## ADDENDUM NO: 001

TO:	Prospective Bidders
FROM:	Parkhill
PROJECT NAME:	UMC OR – 8 RENOVATION
PROJECT NO.:	03.9049.22
DATE:	April 18, 2024

**C1 REFLECTED CEILING PLAN - BOOM SUPPORTS**  
1/4" = 1'-0"

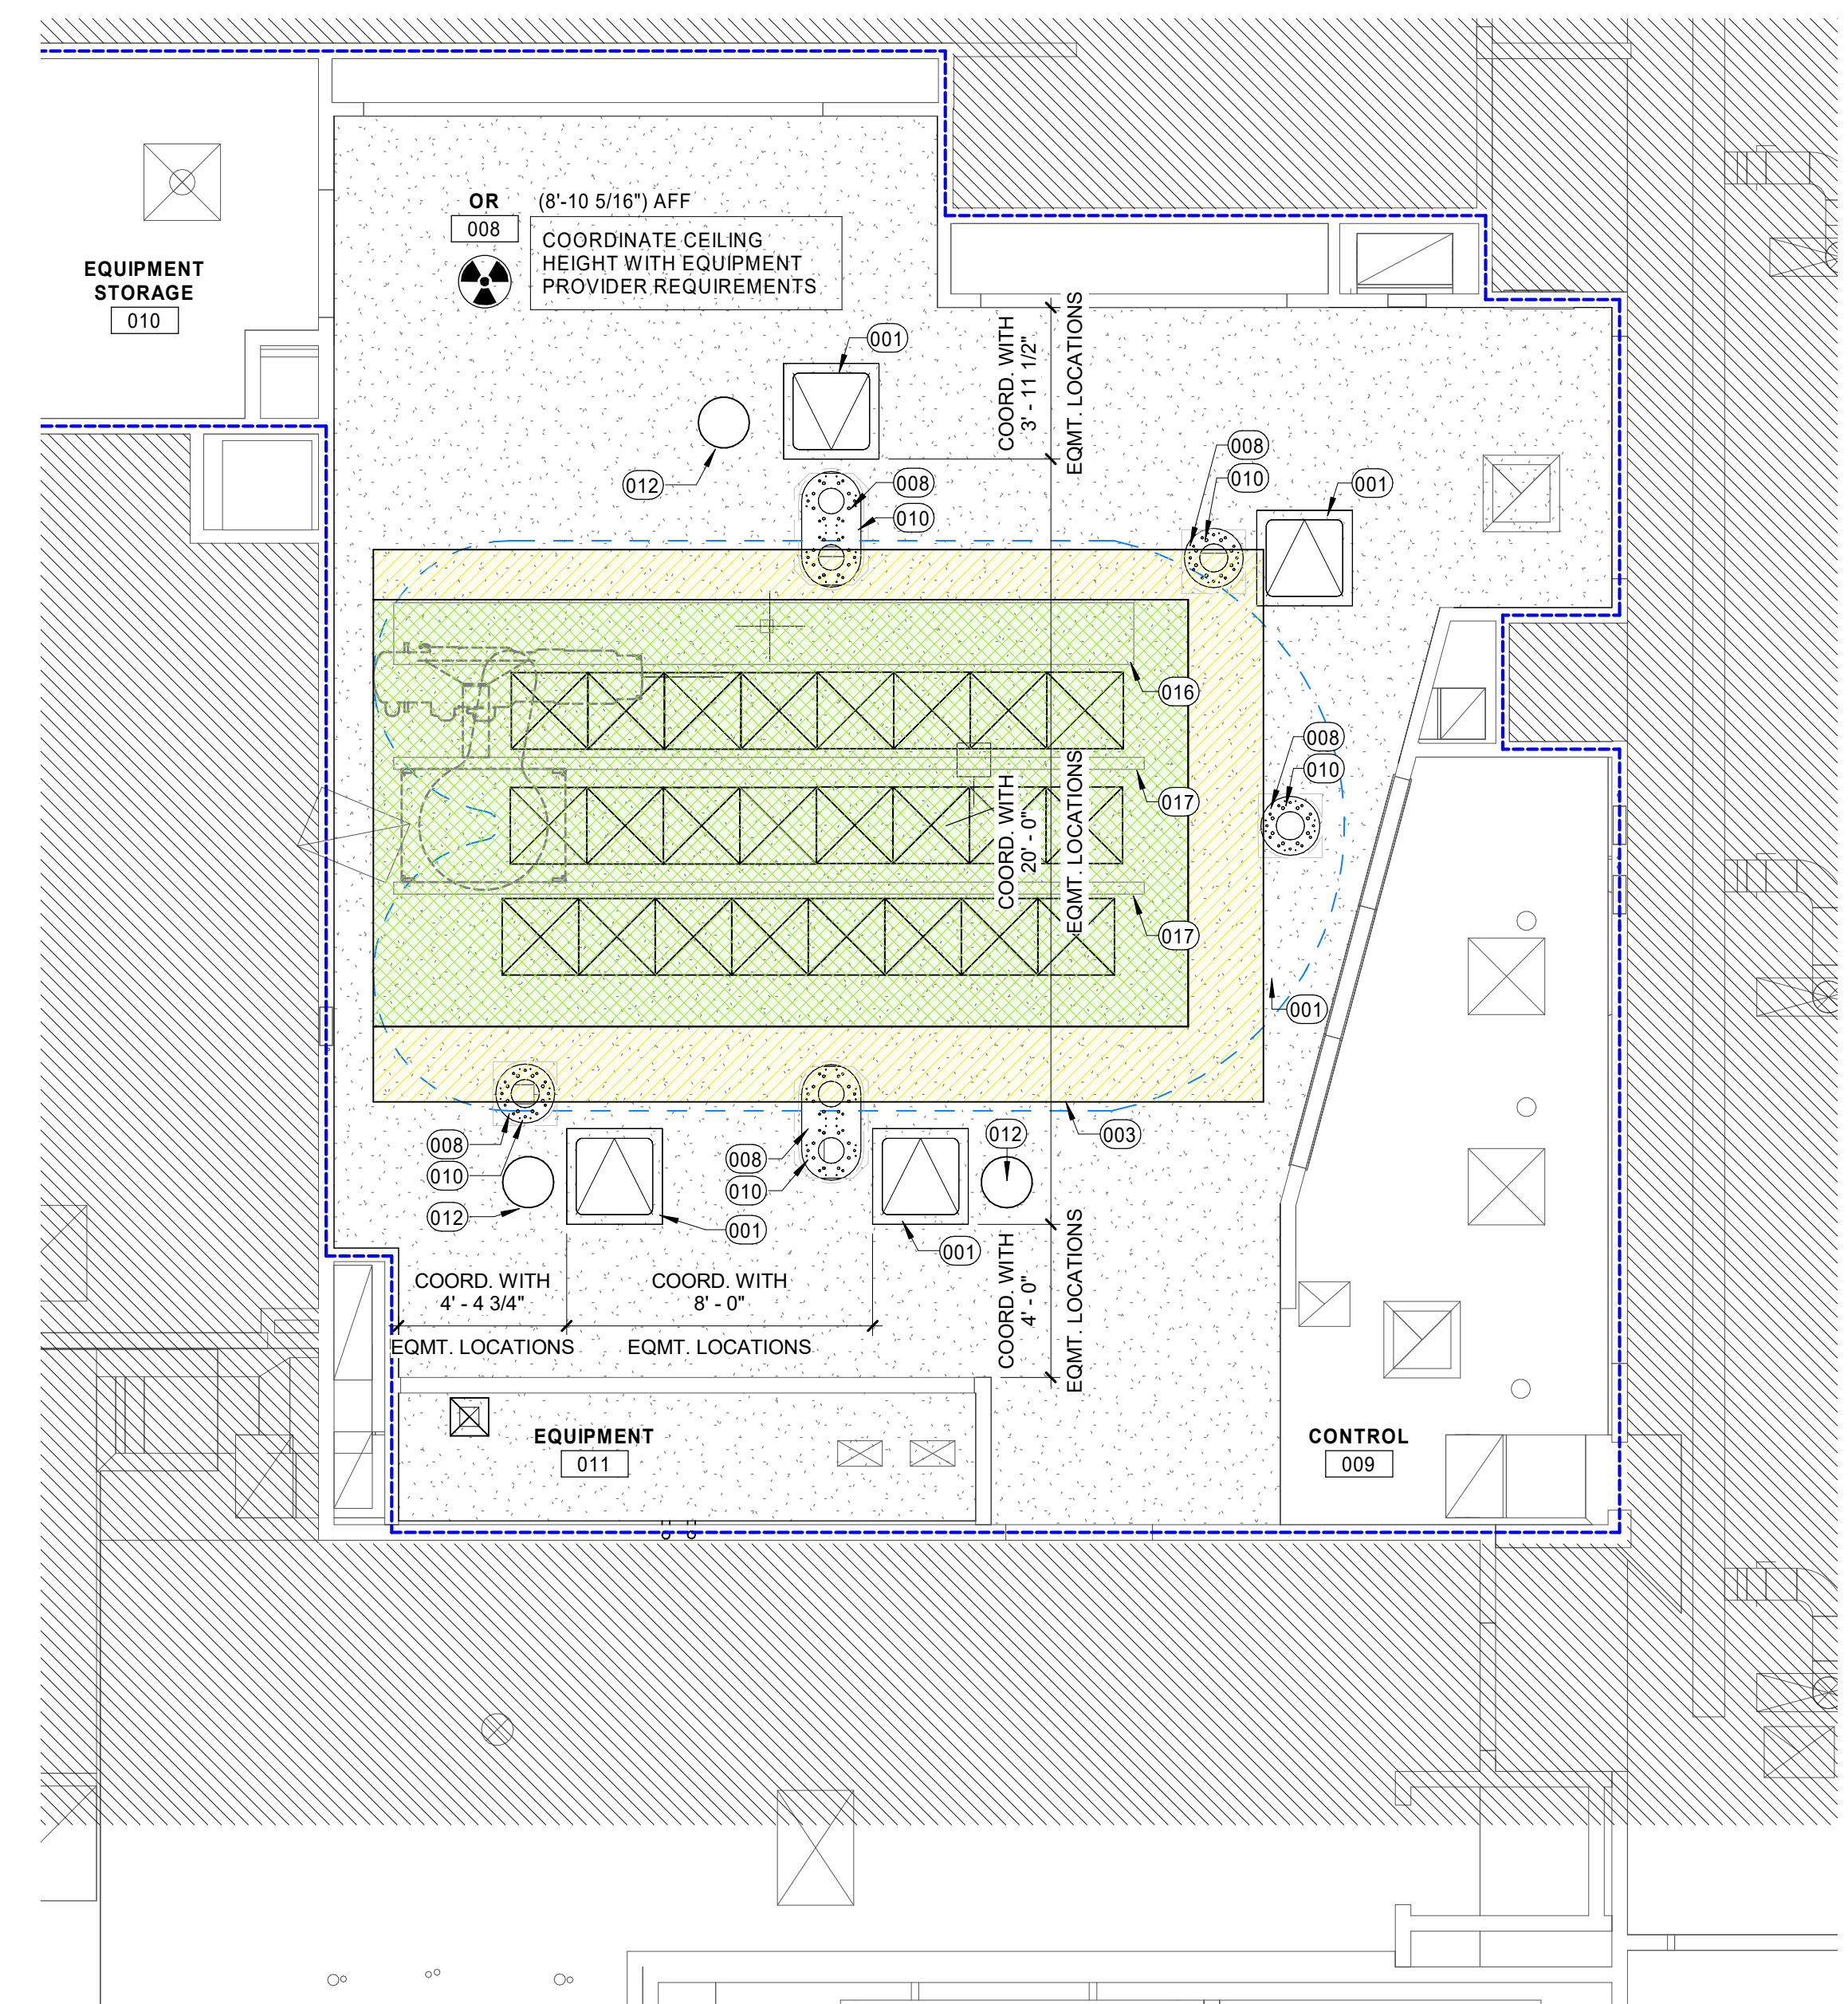
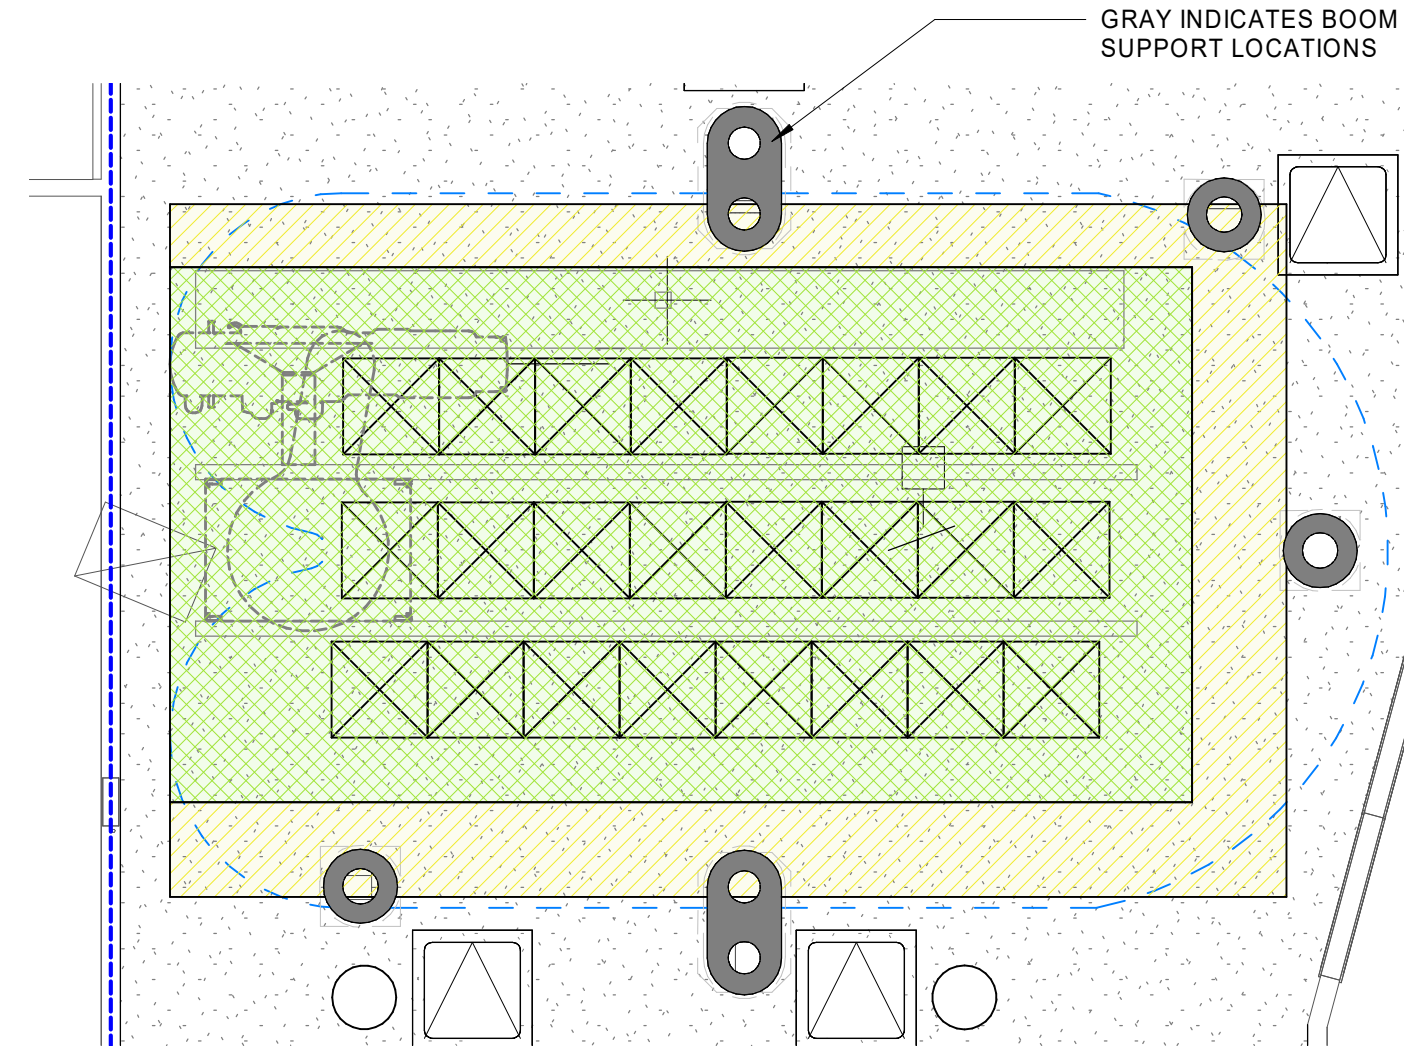
1. SHEET A-131 Reflected Ceiling Plan
  - a. UPDATE: verbiage to keynote 008
  - b. UPDATE: Boom Support Notes on drawing C1

- A. GC COORDINATE LOCATIONS, HEIGHTS, ETC. WITH EQUIPMENT BOOM DRAWINGS. SUBMIT RFI WITH ANY DISCREPANCY BETWEEN, EXISTING DRAWINGS, EQUIPMENT DRAWINGS, AND ACTUAL FIELD CONDITIONS.
- B. SUPPORTS FOR BOOM ANCHOR PLATES SHALL BE ENGINEERED, SEALED, AND SUPPLIED BY UNISTRUT. COORDINATE UNISTRUT REQUIREMENTS WITH EQUIPMENT BOOM DRAWINGS. UNISTRUT DRAWINGS SHALL BE SUBMITTED FOR APPROVAL.
- C. EXISTING STRUCTURAL DRAWINGS CAN BE PROVIDED ONLY FOR REFERENCE. FIELD VERIFY ALL EXISTING CONDITIONS.

- AS INDICATED BY: (#) →
- 001 CEILING ACCESS PANEL; COORD LOCATION WITH EQUIPMENT DRAWINGS TO BE LOCATED NEAR MED GAS PLUMBING; INSTALL FLUSH WITH CEILING FINISH AND PAINT TO MATCH CEILING FINISH; REF INTERIOR
  - 003 COORDINATE CEILING PROTRUSION RESTRICTIONS WITH EQUIPMENT PROVIDER
  - 008 BOOM ANCHOR PLATE; REF C1/A-131 FOR ATTACHMENT TO STRUCTURE ABOVE; COORDINATE FINAL LOCATION WITH EQUIPMENT PROVIDER SITE SPECIFIC DRAWINGS
  - 010 CEILING COVER BY EQUIPMENT PROVIDER
  - 012 SPEAKER; COORDINATE FINAL LOCATION WITH EQUIPMENT INTEGRATION DRAWINGS
  - 016 CABLE DUCT; REFER TO EQUIPMENT PROVIDER DRAWINGS
  - 017 SUPPORT RAIL; REFER TO EQUIPMENT PROVIDER DRAWINGS
